TEXAS UTILITIES ELECTRIC COMPANY, ET AL.*
COMANCHE PEAK STEAM ELECTRIC STATION, UNIT 1
DOCKET NO. 50-445
AMENDMENT TO FACILITY OPERATING LICENSE

Amendment No. 11
License No. NPF-87

ATTACHMENT TO LICENSE AMENDMENT NO. 11

FIGURE 3.4-2

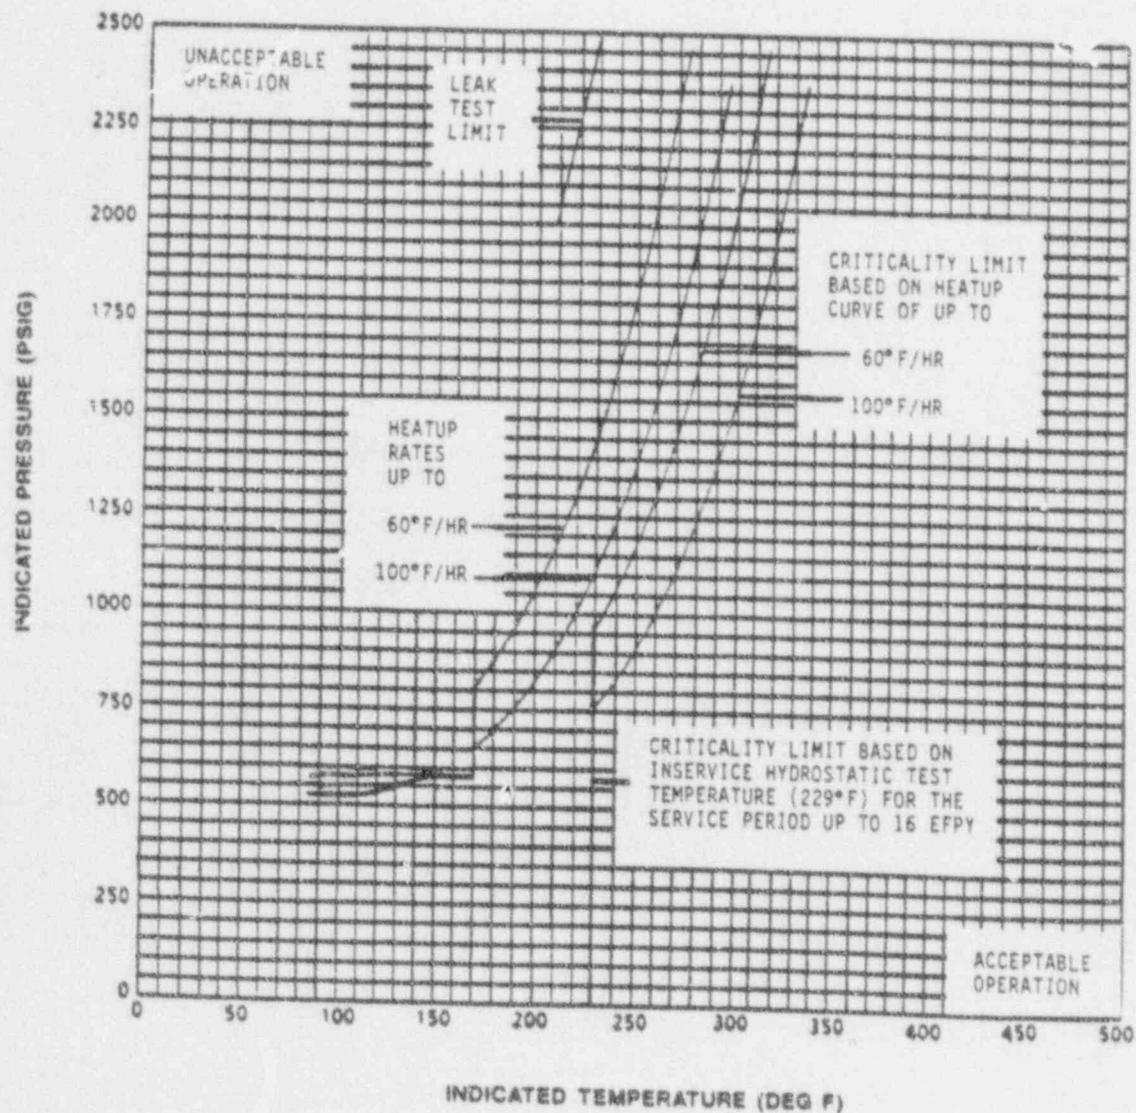
3.4.8.1 The Reactor Coolant System (except the pressurizer) temperature and pressure shall be limited in accordance with the limit lines shown on Figures 3.4-2 and 3.4-3 during heatup, cooldown, criticality, and inservice leak and hydrostatic testing with:

CURVES APPLICABLE FOR HEATUP RATES UP TO 100°F/HR FOR THE SERVICE PERIOD UP TO 16 EFPY. CONTAINS MARGIN OF 10°F AND 60 PSIG FOR POSSIBLE INSTRUMENT ERRORS.
